Re: Permit No. M-1980-244; Cripple Creek & Victor Gold Mining Company; Cresson Project; – Technical Revision 123 – Squaw Gulch Valley Leach Facility – Phase 2B Part 1 Record of Construction Report, Adequacy Review Response

On October 16, 2020, Newmont Corporation's Cripple Creek and Victor Gold Mining Company (CC&V) received the Division of Reclamation, Mining and Safety's (DRMS's) adequacy review of Technical Revision (TR) 123, which includes the Phase 2B Part 1 Record of Construction report dated September 2020. Below are DRMS comments in italics followed by CC&V's responses in bold.

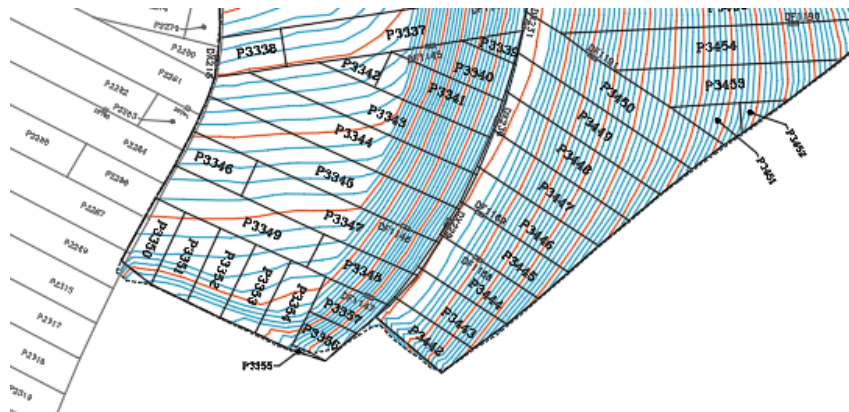
11. Geomembrane Panel Layout As-Built, Drawing No. 9: In the southeast corner of this drawing, panels P3350, P3351, P3352, P3353, and P3354 appear to be deployed in a horizontal alignment (i.e., roughly parallel to the contours). According to Technical Specification No. 02776-0 Geomembrane, field seams "shall be oriented parallel to the line of maximum slope, i.e., oriented down, not across the slope" (reference p. 13, section 3.7.A.1). The purpose of this particular specification is to minimize strain on welded seams and rely more on the tensile strength of the intact manufactured product. Please:

- a. Explain how this layout meets the approved specifications, and

The panels are installed per technical specifications. The grade of the pad drains north, as shown the image below.

As a follow up on a question from DRMS during a phone call on October 28, 2020, the panels deployed in the abandoned haul road are continuations of the panels running down the steeper 40%-50% slopes above. They were deployed in this manner in an effort to minimize the strain of seams and the number of defects/extrusion welding along the toe. Similar deployment methods for the same reasons were used in Phase 1 and Phase 2A Parts 1, 2 and 3.
